March 10, 2023

Project Name: PEARL JUNIOR HIGH MULTIPURPOSE
Project No: 22-056
RE: Updated Civil and Structural drawings.

ADDENDUM NO. 01

C200
 SITE DEMOLITION PLAN

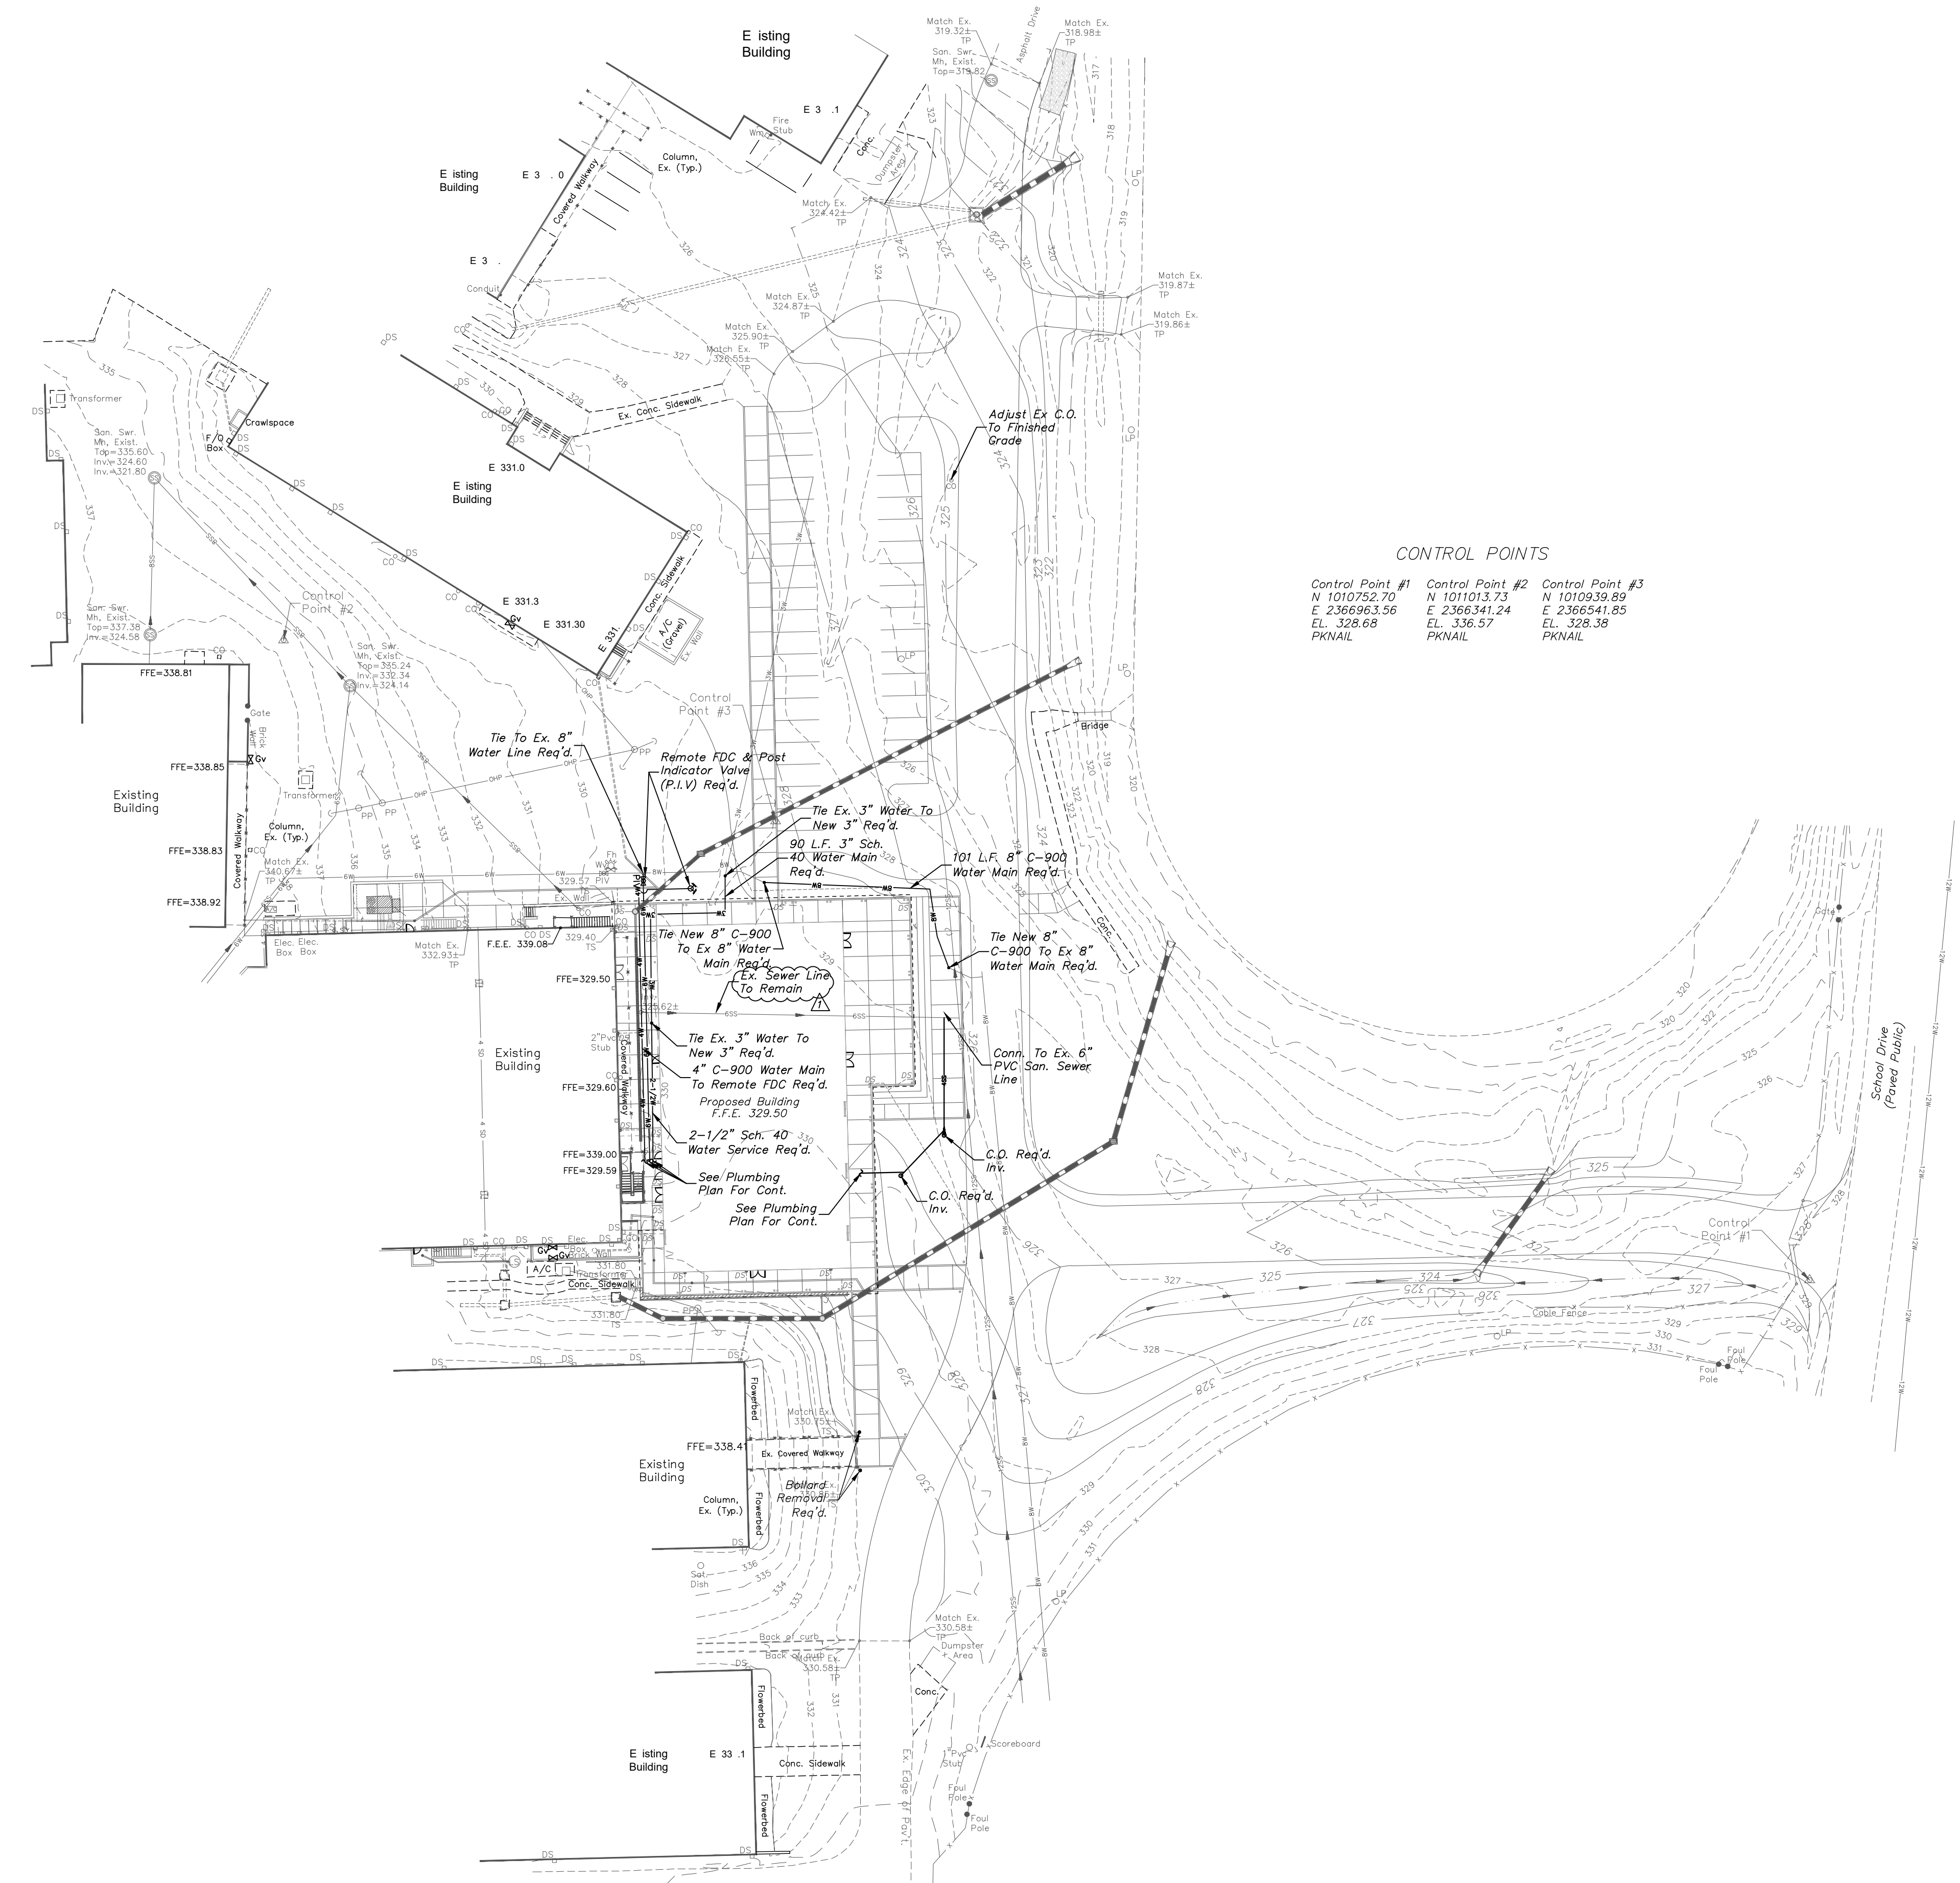
- ITEM NO. 01** *REPLACE* the following sheets with attached revised sheets.
- C200 DEMOLITION PLAN
 - Modified location of pipe location.
 - C300 UTILITY LAYOUT

C300
 UTILITY LAYOUT

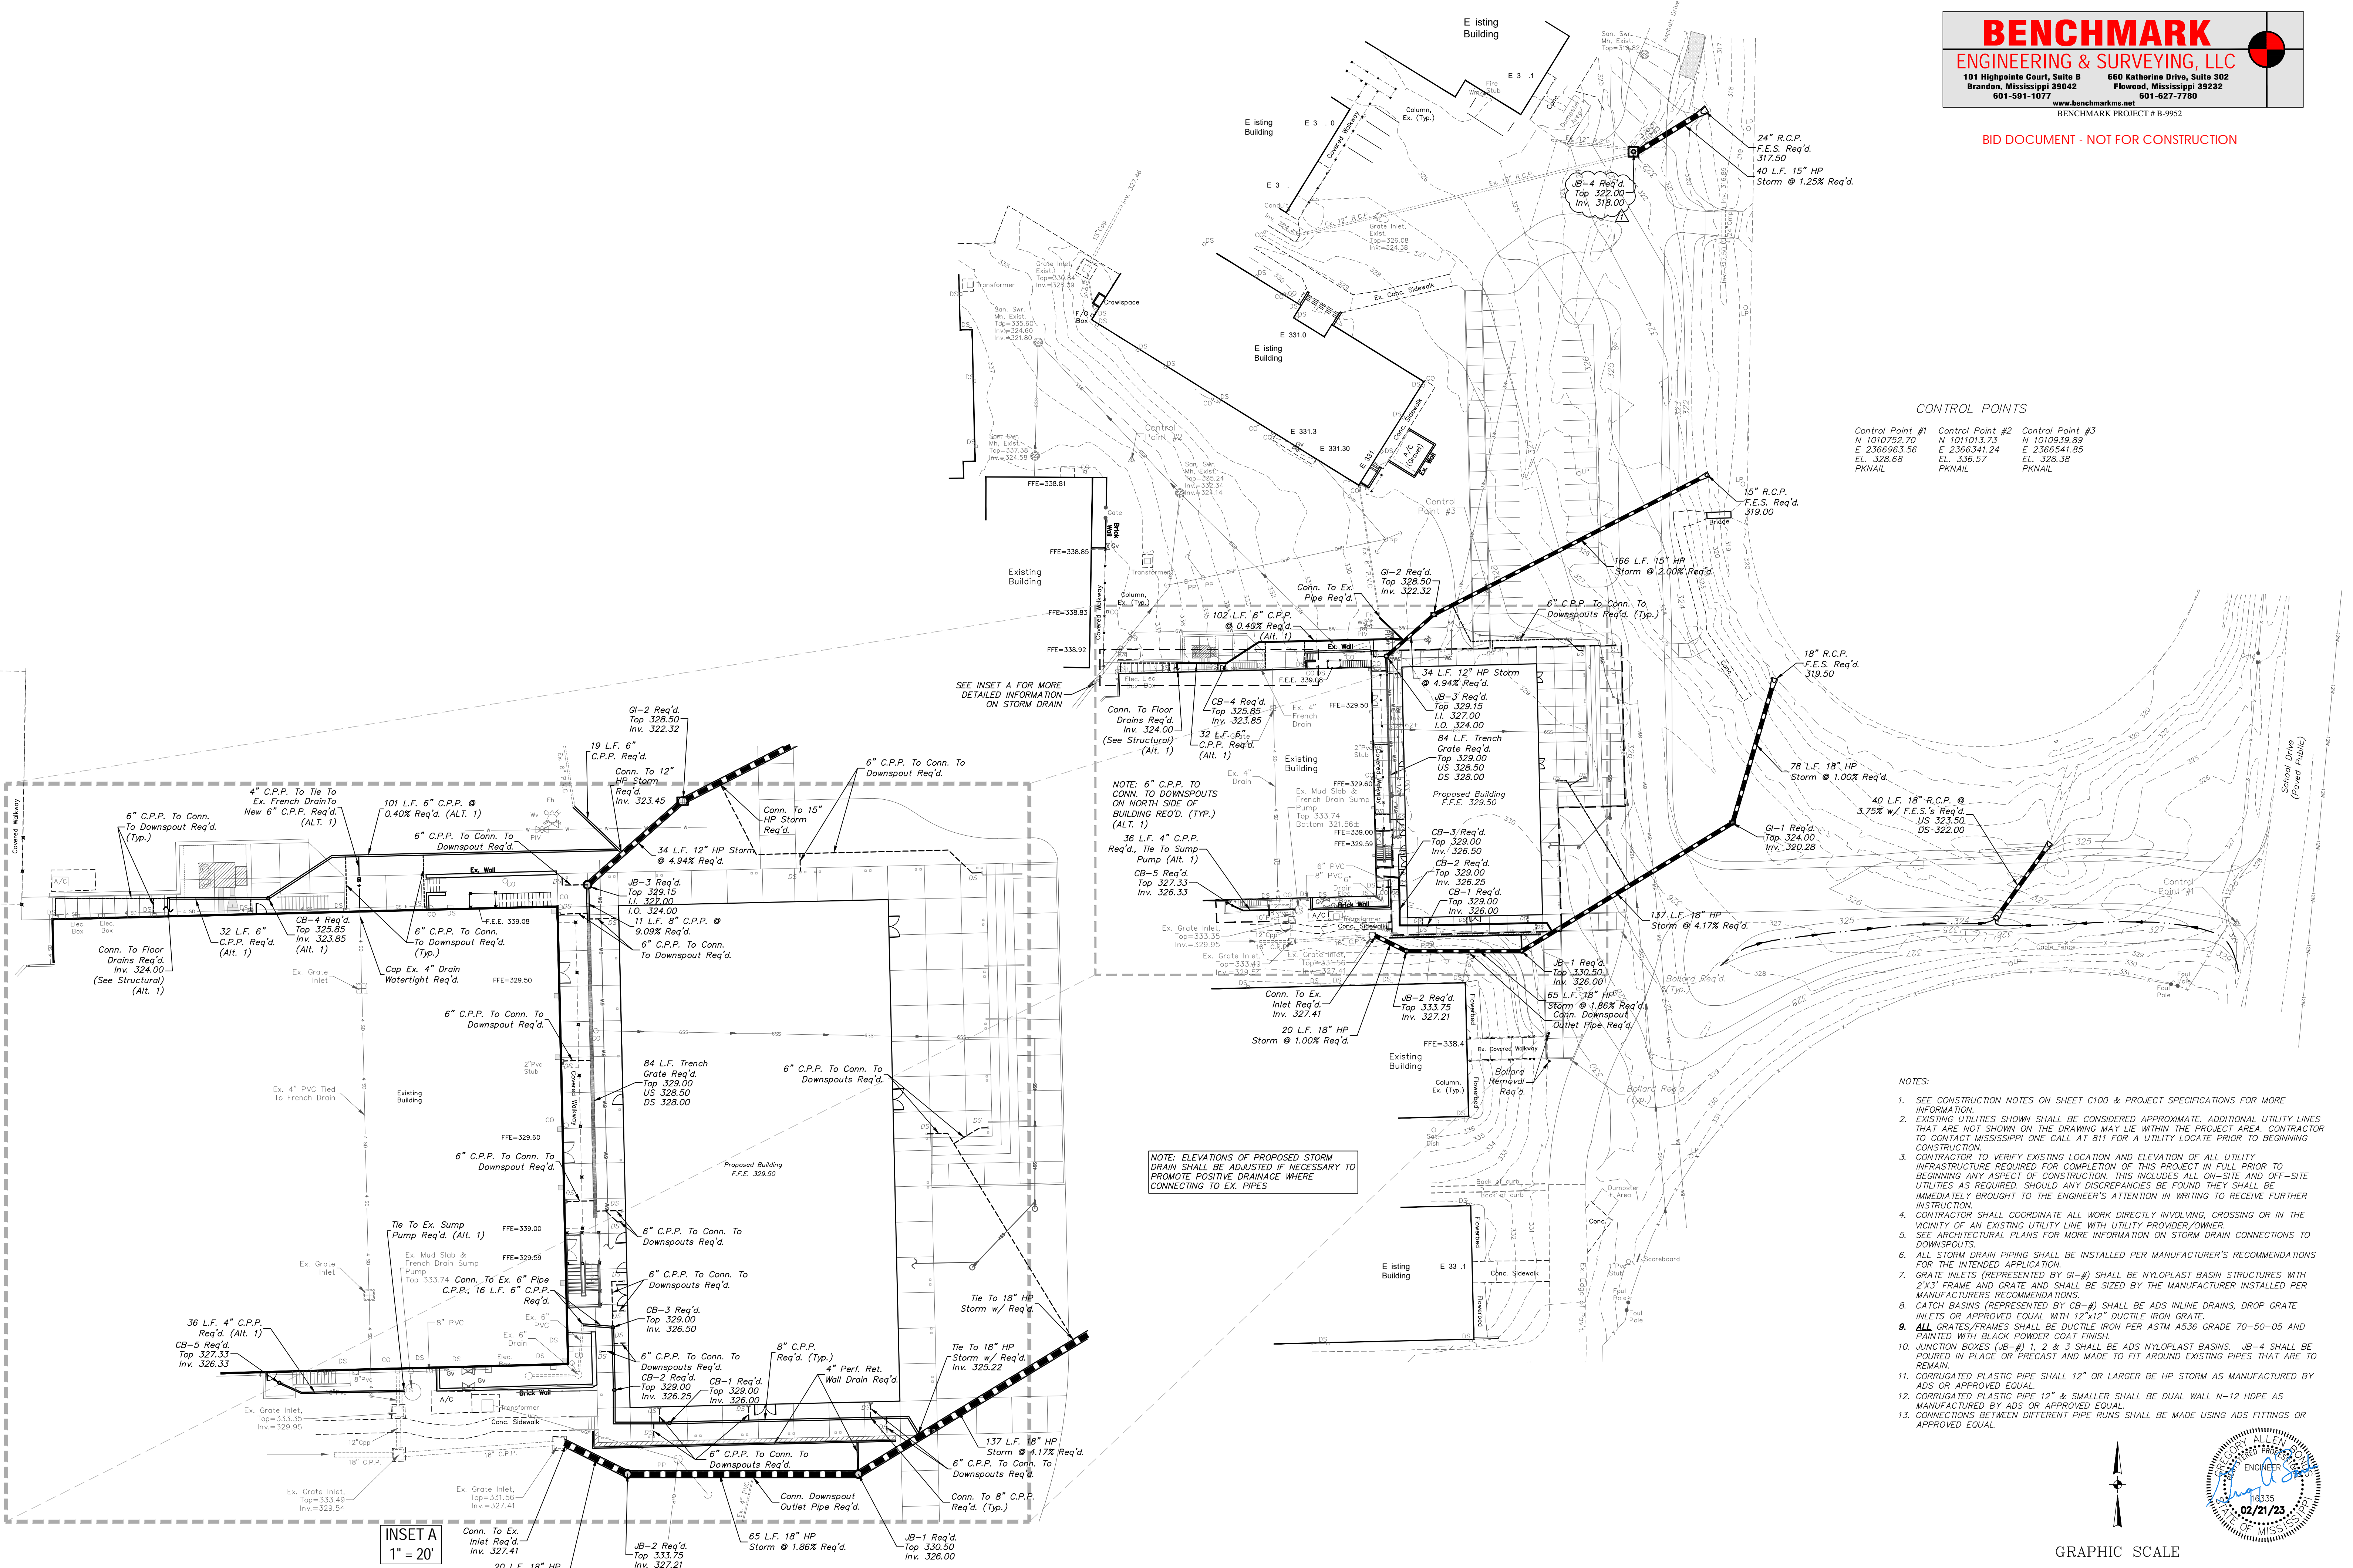
- Confirmed location of existing sewer line
 - C302 DRAINAGE PLAN
 - Modified height of inlet.
 - C303 EROSION CONTROL PLAN
 - Added a Rip-Rap location.
 - S100 STRUCTURAL NOTES

NEW ADDITION - FOUNDATION PLAN

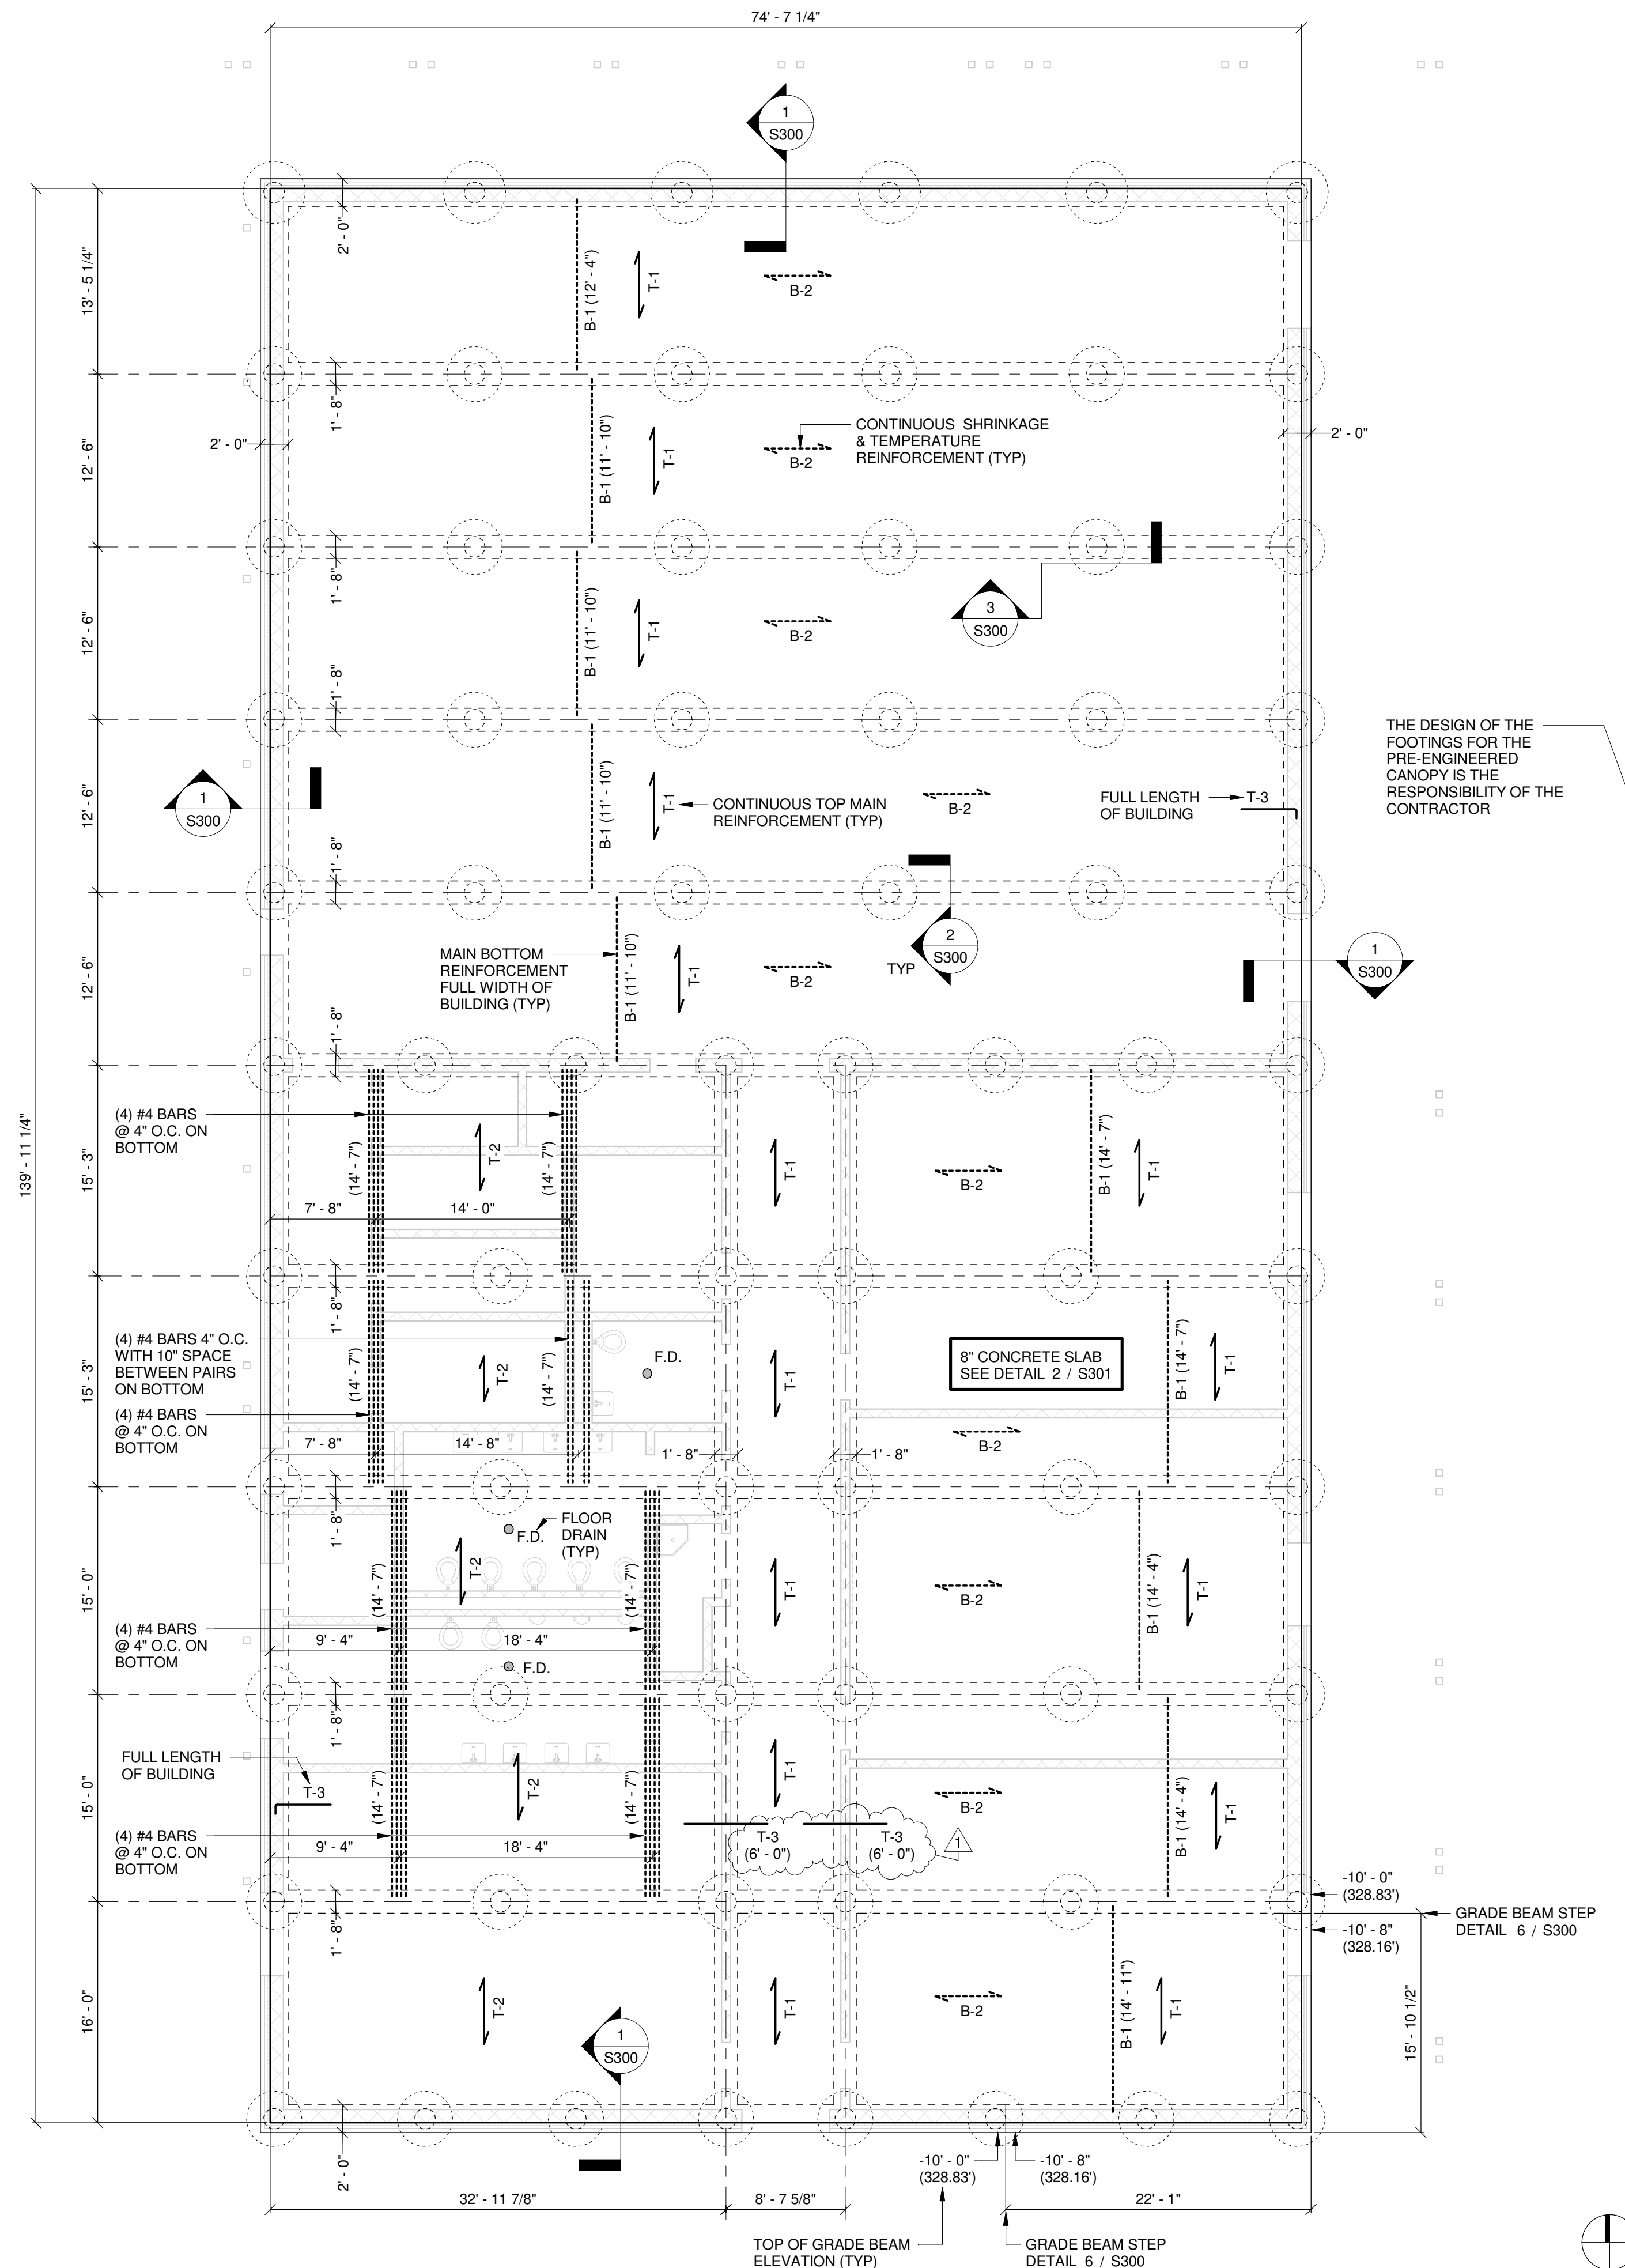
- Modified allowable drilled pier bearing capacity and added void form note.
 - S201 NEW ADDITION FOUNDATION PLAN
 - Revised reinforcement designation.
 - S202 NEW ADDITION CMU WALL PLAN
